Problem B:

Power and Timing Optimization Using Multibit Flip-Flop

Q&A

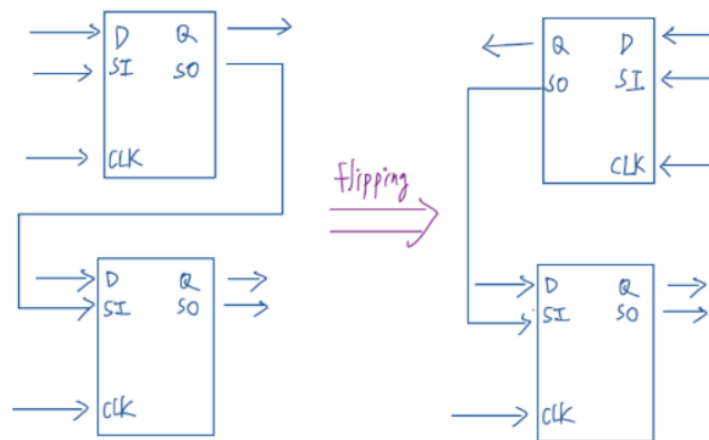
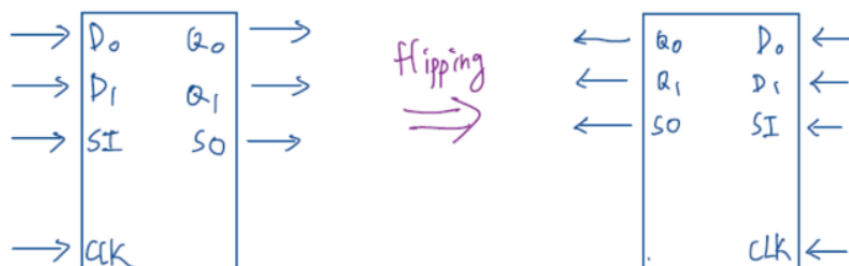
Q5a. Can the pins of the flipflop be flipped as shown in the examples below?

Case 1: flip a single bit FF (the top one)

Case 2: flip all the pins of a MBFF

Case 3: flip the partial pins of a MBFF

A5a. We allow cell flipping as long as cells could be placed legally.

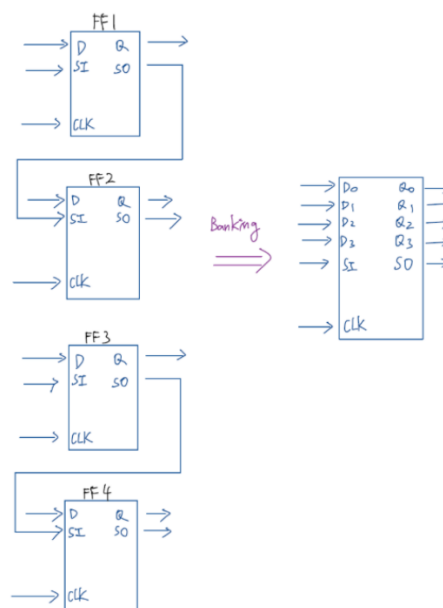
Q5b. Does it mean that the pin locations relative to a flip-flop from the input file can be modified (i.e., the output pin locations can differ from the input) to implement "flipping"?

Or is there an attribute to indicate whether the FF has been flipped in the output file?

A5b. Yes. Please refer to LEF DEF format on how to reflect a flipped cell solution.

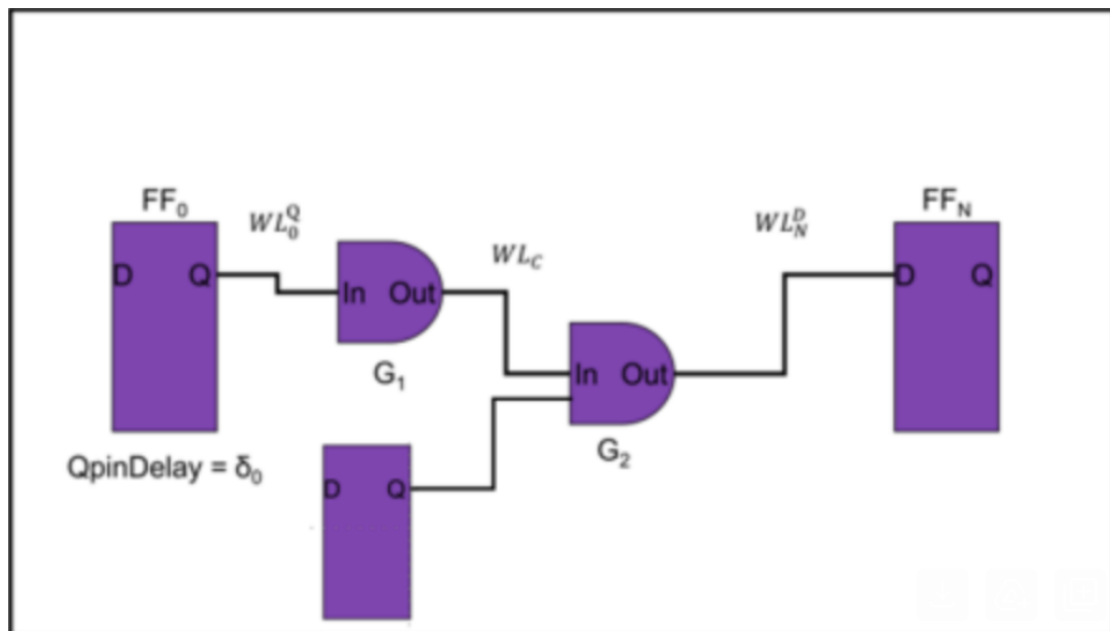
Q10. The problem statement says "All instances must be placed on-site and within the die region." However, it is not explicitly stated whether the die region size or placement row/site information will be included as part of the input.

Will the die area and legal placement sites be provided via the LEF/DEF input files?

Is there any additional information about site dimensions or die boundaries we should be aware of?

A10. Yes. The die area and legal placement sties will be provided via the input files. The legality of contestants' submission, along with the cost metrics, would be evaluated with the latest version of Synopsys Fusion Compiler.
